GENERAL INFORMATION

Applicant:	SICK Product & Competence Center Americas, LLC (user) City of Bloomington Port Authority (owner)
Location:	2501, 2601, 2701 American Blvd. E. and 2600 Lindau Lane
Requests:	1) Rezone 2501 and 2701 American Boulevard E. and 2600 Lindau Lane from LX Lindau Mixed Use (AR-17) to LX(PD) (AR-17) Lindau Mixed Use (Planned Development) (Airport Runway-17); 2) Preliminary development plans for a multi-phase technology campus at 2501, 2601, and 2701 American Boulevard East and 2600 Lindau Lane; 3) Final development plans for Phase I of the technology campus; 4) Preliminary and final plat to adjust property boundaries; 5) Platting variance to defer park dedication for future development phases; 6) Conditional use permit for a multi-phase technology campus.
Existing Land Use and Zoning:	Vacant; LX(AR-17) Lindau Mixed Use(Airport Runway) and LX(PD)(AR-17) Lindau Mixed Use(Planned Development)(Airport Runway)

PROPOSAL

Case PL202100044

Figure 1: Existing and Proposed Zoning Designation

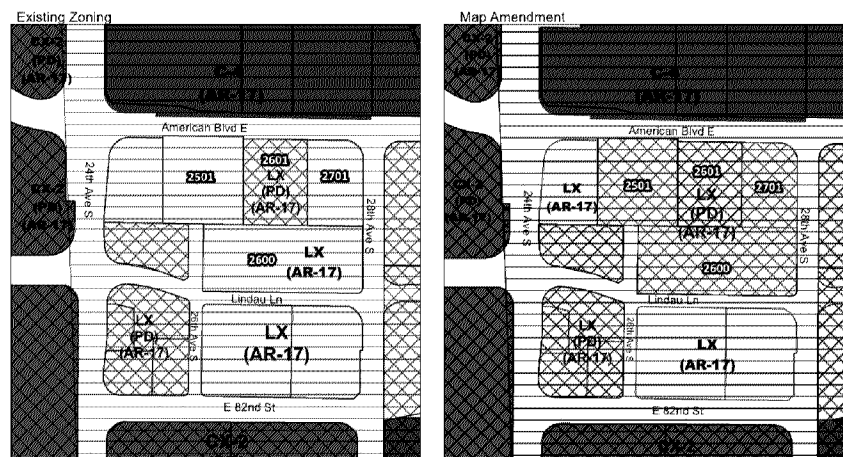
The development area is zoned LX. Creating one cohesive planned development requires all four subject parcels to have the planned development (PD) zoning overlay. One parcel is zoned PD; the rezoning request is to apply the PD overlay to the remaining three parcels. Figure 1 below depicts the existing and proposed zoning for the parcels. The entire area is also encumbered by the AR-17 Airport Runway Overlay zoning district, which would not change. Residential land uses are prohibited in this area given their location along the flight path.

Figure 2: Pre-Cast Concrete Exterior

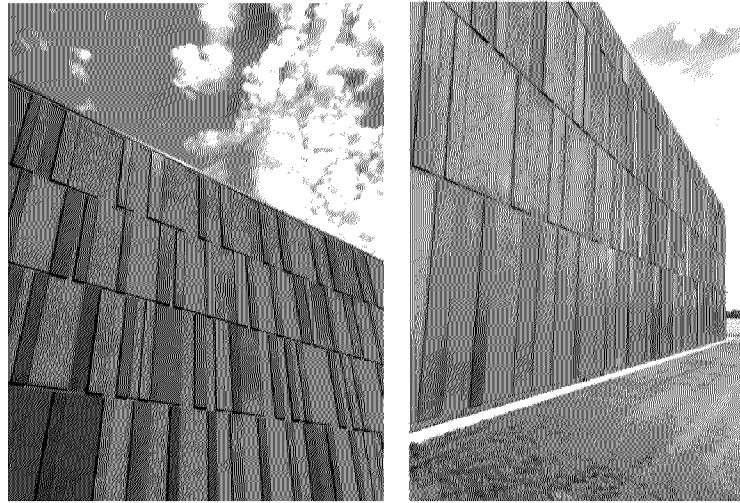
The exterior materials proposed are a mix of glass and pre-cast concrete. Pre-cast concrete, while permitted within industrial zoning districts, requires a deviation from City Code for the LX district. The intent of the limitation is to ensure that an overtly industrial building design is not constructed within a commercial or mixed-use site. The SICK building attempts to balance durability and practicality of a rectangular pre-cast concrete building and the City’s exterior material and structure design requirements. Within the production and warehouse areas, the building design incorporates a significant amount of glass. While the 2 foot to 10 foot transparency requirement would not be met

for the 28th Avenue building façade, the Code requirement only applies to 2 and 10 feet above grade. The proposed building elevation includes a similar level of transparency above 10 feet. Although a slight transparency deviation is required for Phase I, the multi-story office buildings proposed for Phases II and IV are comprised almost entirely of glass. The glass facades, along with future public plazas along Lindau Lane and 28th Avenue S., will create an interesting and high-quality pedestrian environment.
